# NORTHEAST UTILITIES

Millstone Nuclear Power Station, Unit No. 3  
Response to Materials Engineering Branch DSER Open Items

Millstone Nuclear Power Station, Unit No. 3

MTEB 251.1 Appendix G and H, 10CFR50 (Draft SER Section 5.3.2)

Figure 7

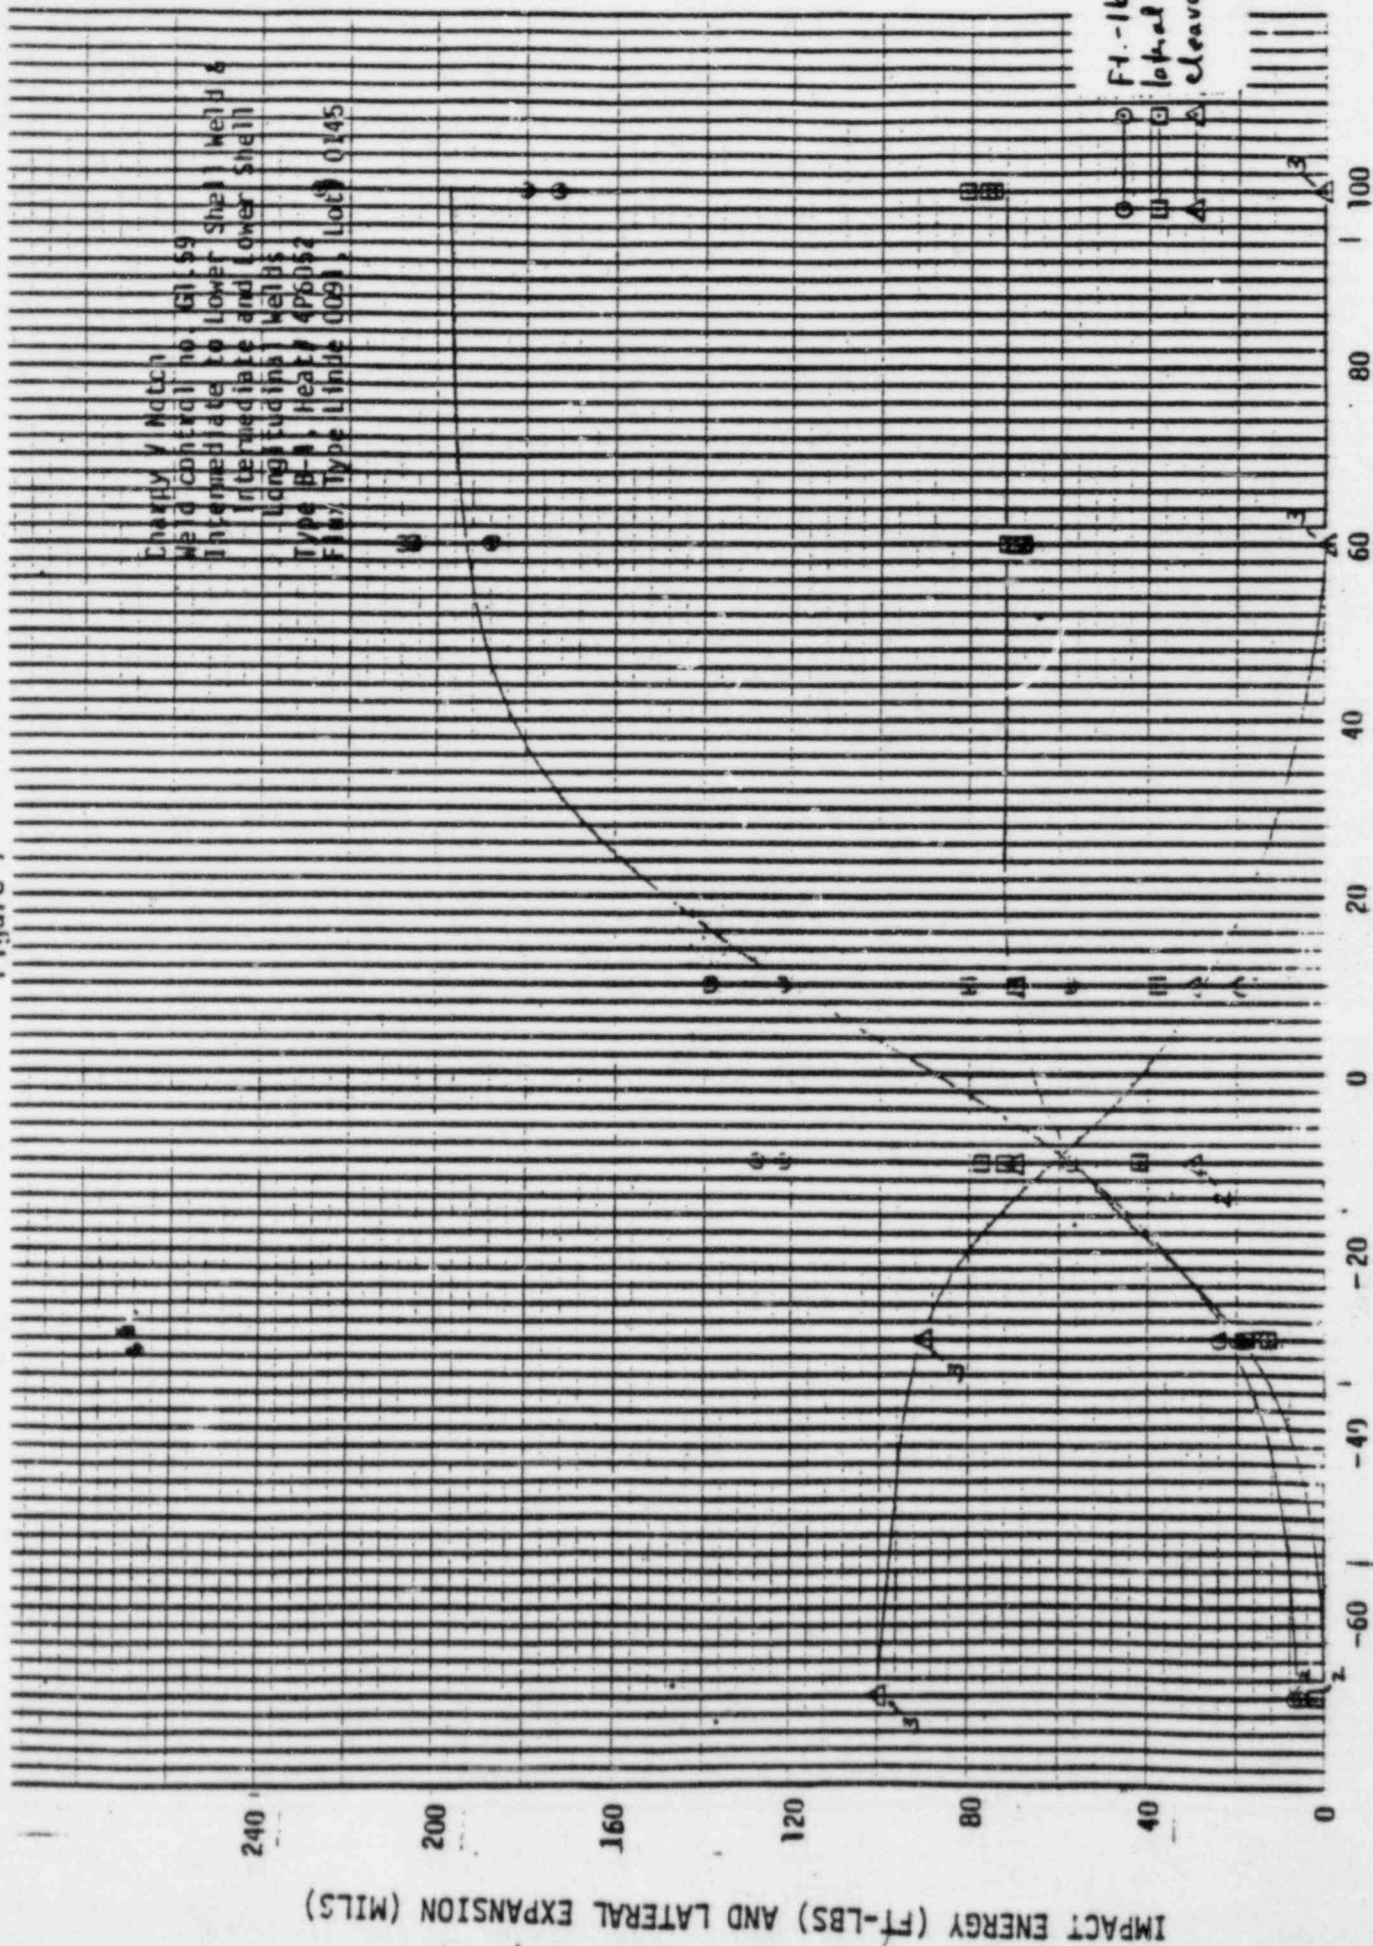
- a. Provide full Charpy V-notch curves for the reactor beltline materials. The curves should be in terms of fracture energy (ft-lbs) and lateral expansion (mils) versus test temperature (°F).
- b. Indicate the base and weld materials in the surveillance capsules. The identification should include the following:
  - (1) Chemical composition
  - (2) Heat treatment
  - (3) Plate number for base materials and weld control number for weld materials.
- c. Indicate the lead factors for all the surveillance capsules and their azimuthal positions within the reactor pressure vessel.
- d. Provide technical justification for the surveillance capsule withdrawal schedule as outlined in Section 5.3.1.6 of the Millstone Nuclear Power Station, Unit No. 3 FSAR.
- e. Provide pressure-temperature limits for the Millstone Nuclear Power Station, Unit No. 3 reactor vessel.

- Part (a) Please find attached (Figures 1 through 7) the Charpy V-notch curves for the Millstone Unit No. 3 reactor beltline materials. These curves originate from Combustion Engineering test data.
- (b) Intermediate shell plate B9805-1, Lukens heat no. C4039-2 is the surveillance base material. The chemical composition (C-E analysis) and heat treatment of plate B9805-1 is given in Table 1.
